DEVELOPMENT APPLICATION**2 64 Pellisier Road, Putney - Partial demolition, alterations and additions to existing dwelling - LDA2020/0327**

**City of Ryde
Local Planning Panel Report**

DA Number	LDA2020/0327
Site Address & Ward	64 Pellisier Road, Putney East Ward
Zoning	R2 Low Density Residential
Proposal	Partial demolition, alterations and additions to existing dwelling.
Property Owner	Sarah Balestriere
Applicant	James Balestriere
Report Author	Deren Pearson – Assessment Officer
Lodgement Date	28 September 2020
No. of Submissions	Four (4) submissions received with three (3) objecting to the development.
Cost of Works	\$374,000.00

Figure 10 Proposed New First Floor Plan

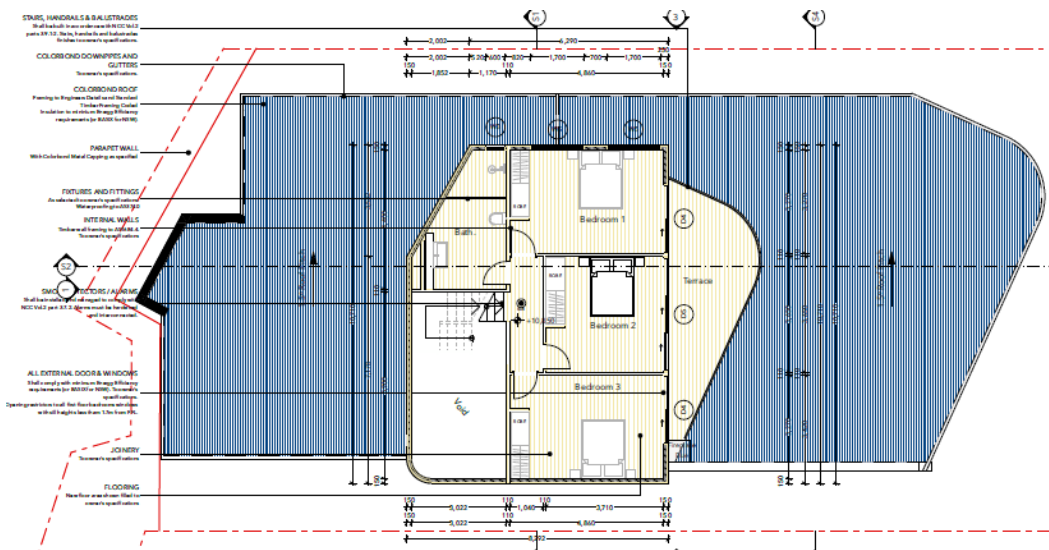
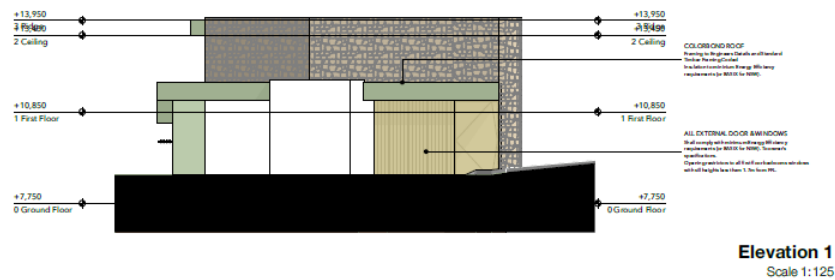
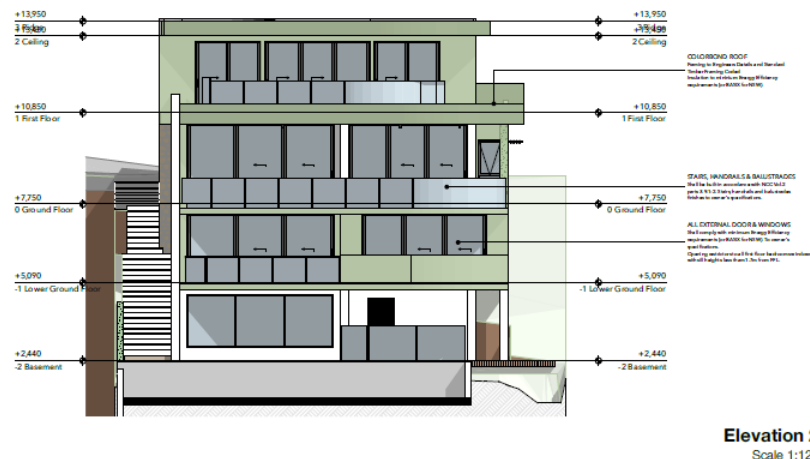
Comment: Concern was raised regarding the floor to ceiling height of the proposed first floor and the scope to reduce the height of this level. It is acknowledged that there is scope to reduce the height of the proposed first floor. Proposed floor to ceiling heights contribute to the height of the building and the impact on views from the neighbours to the west. The height of the building and the impact on views form part of the reasons for the recommended refusal of the application.

Figure 17 Maximum proposed building height

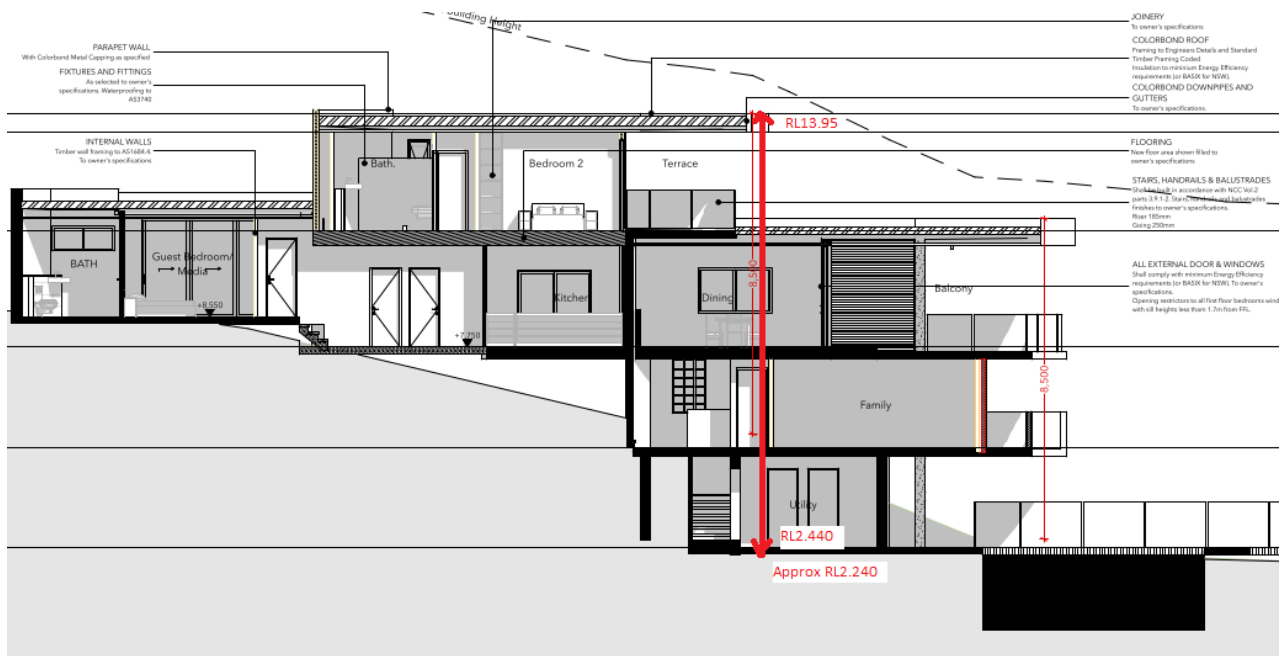
The height non-compliance is limited to the roofed terrace area at the highest point of the building. The applicant has not submitted a Clause 4.6 request to vary the development standard for the height of the building. Notwithstanding the absence of a written variation request, the proposal does not comply with the objectives of the development standard and is therefore not supported. The objectives aim to minimise the impact of development on the amenity of surrounding properties and the proposal would result overlooking of the neighbouring properties and would partly impact upon the views from No. 60 Pellisier Road. The non-compliance with the maximum building height is recommended as a reason for refusal of the application.
